## MEMORANDUM

**Subject: SR 520, I-5 to Medina: Bridge Replacement and HOV Project –  
Revised Design of the Temporary Eastside Over-water Staging Area**

## Revised Design of the Temporary Eastside Over-Water Staging Area

**Exhibit 1 - Previous Design (January 2012 NEPA Reevaluation)**

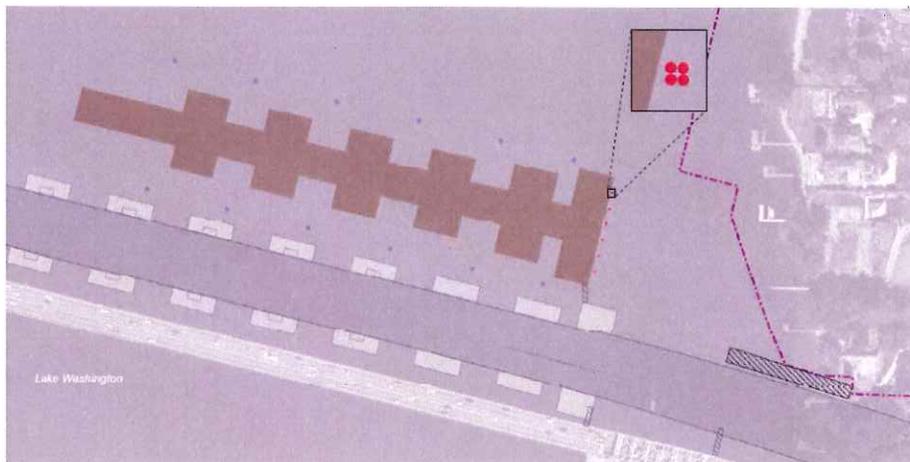
In the SEPA Addendum and NEPA Environmental Reevaluation, WSDOT identified one over-water staging area located near the east approach, for pontoon outfitting and to assemble bridge elements (see Exhibit 1 below). This eastside staging area was proposed to have been located approximately 100 feet north of the new floating bridge alignment and approximately 450 feet from the eastern shore of Lake Washington, within the limits of construction. To accommodate up to 16 pontoons (longitudinal and supplemental) and associated barges, this staging area could have resulted in up to 4.1 acres of over-water coverage at any given time during the 3-year bridge construction period.

The pontoons would have been secured at the eastside staging area with temporary Danforth type anchors and six mooring dolphins, each consisting of four 30-inch-diameter steel pilings. The piles would be installed with vibratory methods and, if needed, could have been proof-tested with an impact hammer. The mooring dolphins would have been located in shallow water (approximately 40 feet deep), and would have displaced approximately 118 square feet of benthic substrate.

**Exhibit 2 - Previous Design (Internal Memorandum, May 2012)**

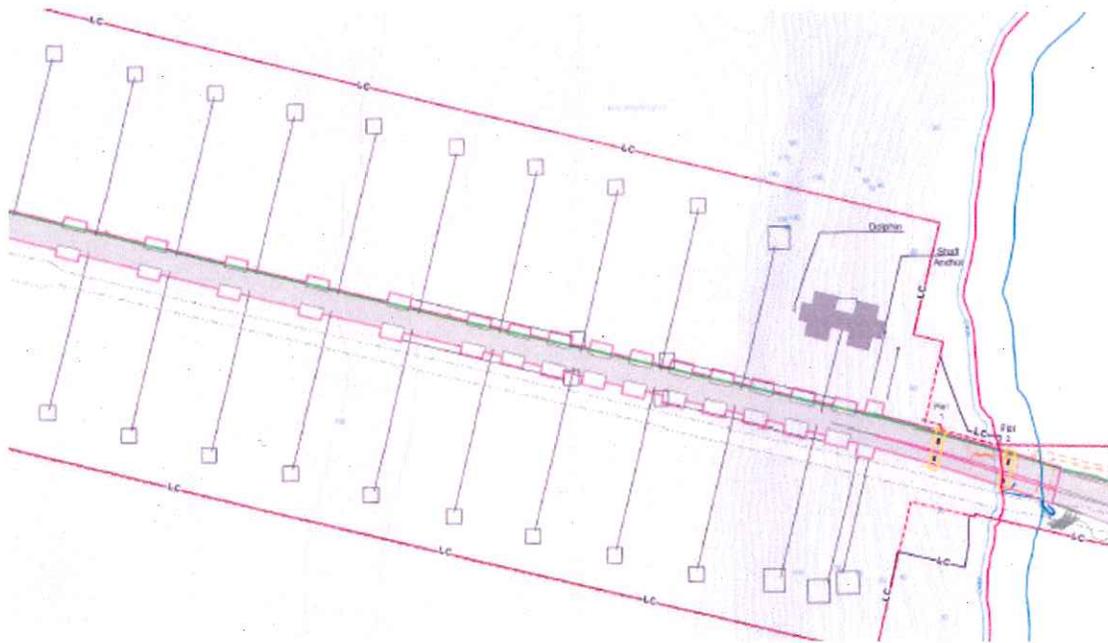
The 16-pontoon staging area that was proposed in January 2012 was reduced to a staging area designed for single-pontoon moorage. The changes were documented in the internal May 2012 memorandum. The May 2012 design accommodates one longitudinal pontoon and allows for the joining of four supplemental pontoons (see Exhibit 2 below). The foundational support for the staging area has been installed in Lake Washington, and is located approximately 500 feet north of the new bridge alignment and approximately 400 feet from the eastern shore of Medina. As with the January 2012 design, the staging area does not extend outside of the limits of construction and will be removed after construction is completed, in approximately 3 years.

Upon delivery, the longitudinal pontoon will be secured at the west end of the staging area to a mooring dolphin, which consists of three 60-inch-diameter steel pilings. The east end of the staging area utilizes the steel casing for one of the permanent drilled shaft anchors from the floating bridge. Pontoon assembly will be positioned between the mooring dolphin and the shaft anchor using mooring lines attached to the corners of the longitudinal pontoon. The piles and shaft casing were installed using vibratory methods only.

This smaller design has reduced the overall footprint and impact to the benthic substrate of Lake Washington compared to the January 2012 design, which was described in the SEPA Addendum and NEPA Environmental Reevaluation. The maximum over-water coverage decreased from an anticipated 4.1 acres to approximately 1.2 acres, and the impact to benthic substrate decreased from 118 square feet to approximately 59 square feet. The changes reduced the overall number

**Exhibit 3 – Current Design (two eastside staging areas)**

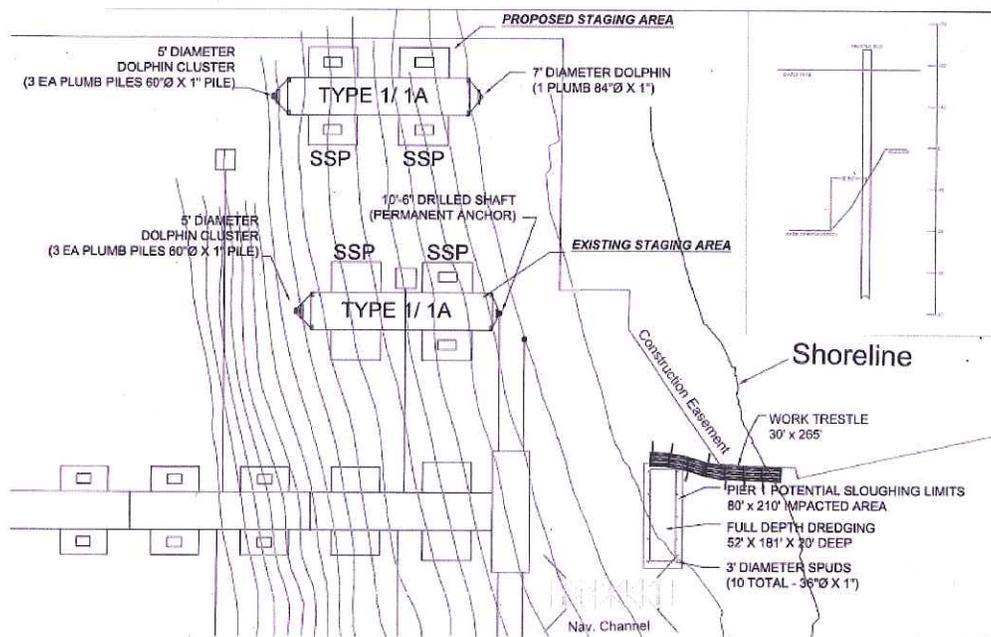
The staging area designed in May 2012 can adequately accommodate pontoon outfitting, and the reduction in size and capacity from the January 2012 design was not expected to delay the current bridge construction schedule. However, a revision to the design is now necessary because of recent delays in pontoon construction. Consistent with the discussion included in the May 2012 memorandum, WSDOT now proposes to install a second single-longitudinal pontoon staging area. The May 2012 memorandum noted that “[i]f WSDOT decides that this staging area would be needed to maintain schedule and progress, appropriate environmental documentation would be prepared at that time.” The staging area remains an integral component of construction, and installation of a second staging area that closely resembles the May 2012 design will aid in timely project delivery.

The second staging area included in this proposed design would have a configuration similar to the May 2012 single-longitudinal pontoon staging area; it would accommodate one longitudinal pontoon and allow for the joining of four supplemental pontoons (see Exhibit 3 below). Simply, an additional staging area would be installed on the lake, and would be a close replica of the May 2012 design.

The east end of the staging area would utilize one 84-inch steel pile, and the west end would be secured with a mooring dolphin that consists of three 60-inch-diameter steel pilings. The piles would be installed using a vibratory pile driver; no impact pile driving is anticipated. Pontoon assembly would be positioned between the mooring dolphin and the shaft anchor using mooring lines attached to the corners of the longitudinal pontoon.

The second staging area would be located approximately 400 feet north of the existing (May 2012) staging area; 900 feet north of the existing bridge and approximately 300 feet from the Medina shoreline. Consistent with the previous designs, the staging area will not extend outside of the limits of construction, and will be removed after construction is completed, in approximately 3 years.
